ADDENDUM No. 4

Date January 29, 2013

Project Name Walnut Creek WWTP WRI Tank Assessment & Repairs

C.I.P. No. 5267.027

HIGH SERVICE PUMP STATION FLOOR PLAN - I&C MODIFICATIONS

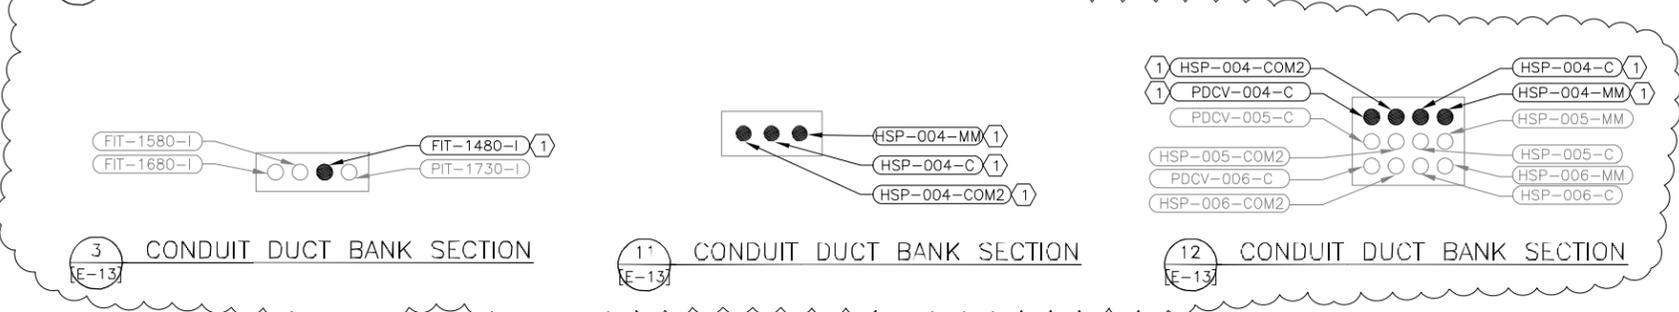
1. **Drawing E-4:** Delete reference to Duct Bank Section 17/E-8 located near the west side of the High Service Pump Station.
2. **Drawing E-8:** Delete Duct Bank Section Detail 6 in its entirety and replace with "Not Used".
3. **Drawing E-13:** Remove sheet in its entirety and replace it with the attached sheet E-13.
